Access Compliance Report

(Curb Ramps)

Intersection ID: 53750	Main Street: SPRINGWOOD_ESTATE_DR	Cross Street: SAGAMORE_HILL_DR	Location: NW
ADA ID: 854AEFC9C33D	Ramp Type: Perp	Initial Pass/Fail: Fail	Overall Compliance: No
Severity Score: 10			
Codes/Mitigation Info/Possible Solution		Field Measurements/Component Compliance

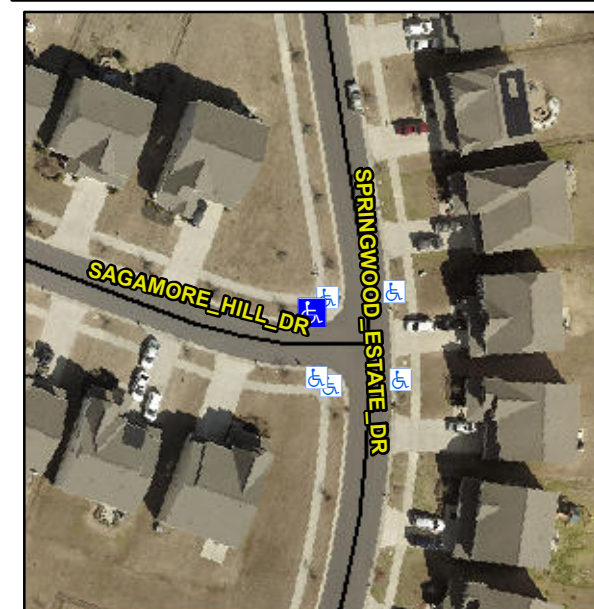
Not Found, R304.5.1, R304.5.3

Compliance	Description	Data	Compliance	Description	Data
N/A	Ramp Length (in)	99.0	Yes	Ramp Slope (%)	6.8
No	Ramp Width (in)	46.0	No	Ramp XSlope (%)	2.8
N/A	Flare Type LT	N/A	N/A	Flare Type RT	N/A
N/A	Flare Slope LT (%)	N/A	N/A	Flare Slope RT (%)	N/A
N/A	Flare Traversable LT?	N/A	N/A	Flare Traversable RT?	N/A
N/A	Landing Length (in)	N/A	N/A	DWS Provided?	N/A
N/A	Landing Width (in)	N/A	N/A	DWS Contrast?	N/A
N/A	Landing Slope (%)	N/A	N/A	DWS Length (in)	N/A
N/A	Landing X Slope (%)	N/A	N/A	DWS Full Width?	N/A
N/A	Landing Curb? (Y/N)	N/A	N/A	DWS Offset (in)	N/A
N/A	Shared Landing?	N/A			
N/A	Gutter Ponding?	N/A	N/A	Gutter Slope (%)	N/A
N/A	Gutter Lip Ht (in)	N/A	N/A	Gutter X Slope (%)	N/A
N/A	Painted X Walk1?	No	N/A	Painted X Walk2?	N/A
	X Walk 1 Direction	To S		X Walk 2 Direction	N/A
N/A	X Walk 1 Width (in)	N/A	N/A	X Walk 2 Width (in)	N/A
	X Walk 1 Slope (%)	3.8		X Walk 2 Slope (%)	N/A
	X Walk 1 X Slope (%)	4.5		X Walk 2 X Slope (%)	N/A

Remove & Replace Entire Ramp.
